## SERVICE BULLETIN NO. 246 - PIPER

Modification of Oxygen Cylinder Rear Retaining Strap Piper Part Number 758 109

PA-30 Twin Comanches ( **NOTE:** Applicable only to aircraft that have had an oxygen system installed at the factory or aircraft that have had Piper Oxygen Installation Kit 757 100 installed.)

#### SKETCH

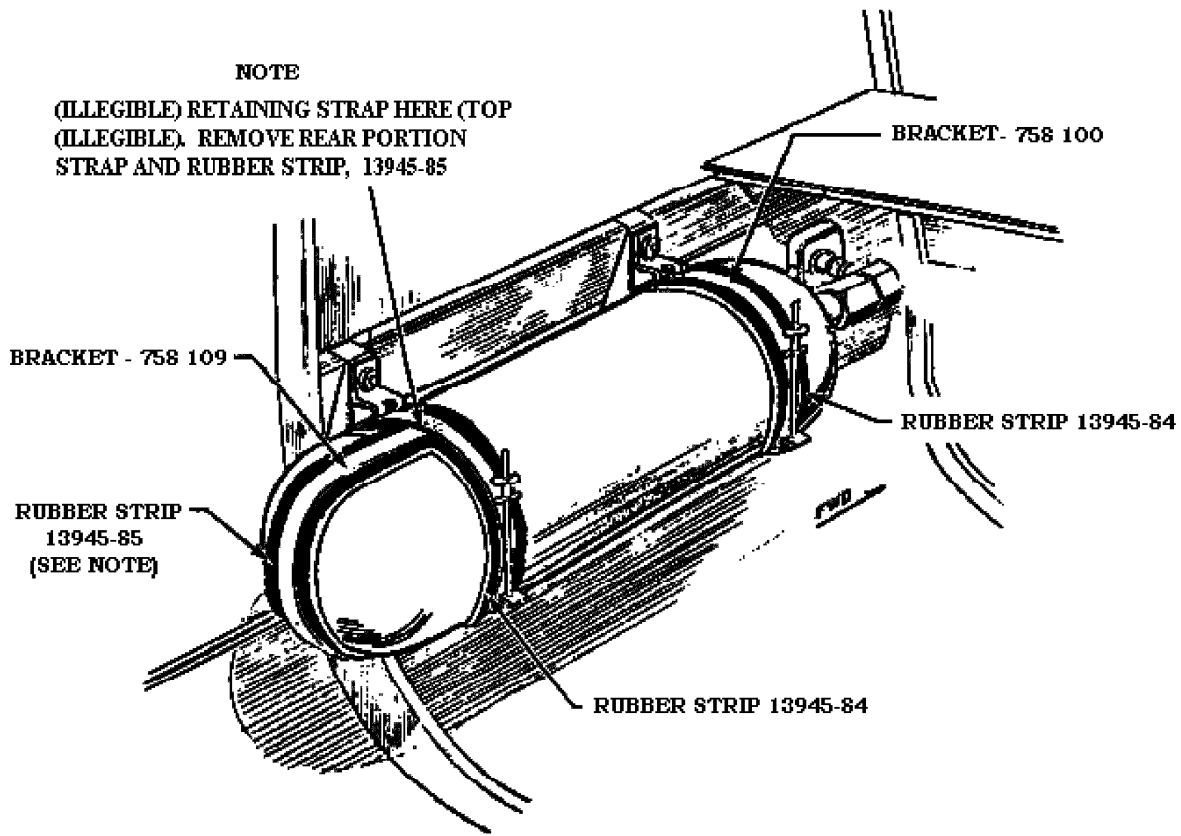
Modification of the oxygen cylinder rear retaining strap part number 758 109 to preclude the possibility of the strap rubbing the rudder control cable.

(ILLEGIBLE) RETAINING STRAP HERE (TOP  
(ILLEGIBLE). REMOVE REAR PORTION  
STRAP AND RUBBER STRIP, 13945-85
